# SERVICE BULLETIN

<b>SERVICE BULLETIN</b>		No.: MSB-97E52-001	
		Date: 1997-04-30	<Model> <M/Y>
<b>Subject:</b> ADDITION OF SRS AIR BAG MAINTENANCE PROCEDURE		ALL MODELS	91-10
<b>Group:</b> INTERIOR	<b>Draftno:</b> 96-AL-022		
<b>INFORMATION</b>	OVERSEAS SERVICE DEPT	 R. USAMI - MANAGER QUALITY INFORMATION ANALYSIS

In the SRS air bag troubleshooting, items of cause of trouble in the inspection procedure for each diagnostic trouble code, have been added.

# 52B-12 SUPPLEMENTAL RESTRAINT SYSTEM (SRS) - Troubleshooting

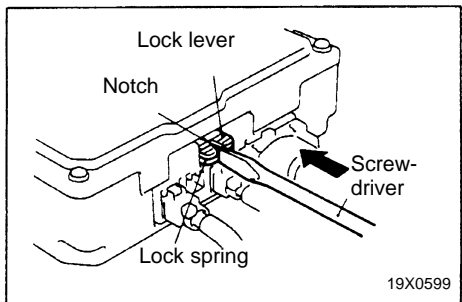
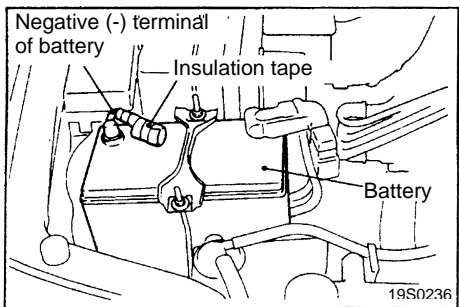
Code No. 21,22 Air bag module (Driver's side squib) system	Probable cause of trouble
(Explanation) These codes are output when the resistance value between the air bag module (squib) terminals in the SDU is out of the normal range. The probable causes of trouble associated with the respective codes Nos. are as follows. <Refer to the chart 1.>	Defective clock spring
	Open-circuit in clock spring due to inappropriate neutral position
	Defective harness, connector
	Defective air bag module (driver's side squib)
	Defective SDU

<Added>

Code No.	Probable cause of trouble
21	<ul style="list-style-type: none"> <li>Air bag module (driver's side squib) or harness short-circuited</li> <li>Clock spring short-circuited</li> </ul>
22	<ul style="list-style-type: none"> <li>Air bag module (driver's side squib) or harness open-circuited</li> <li>Clock spring open-circuited</li> <li>Disconnected connector in the driver's side air bag module (squib)</li> <li>Open-circuit in clock spring due to inappropriate neutral position</li> <li>Connector in loose contact</li> </ul>
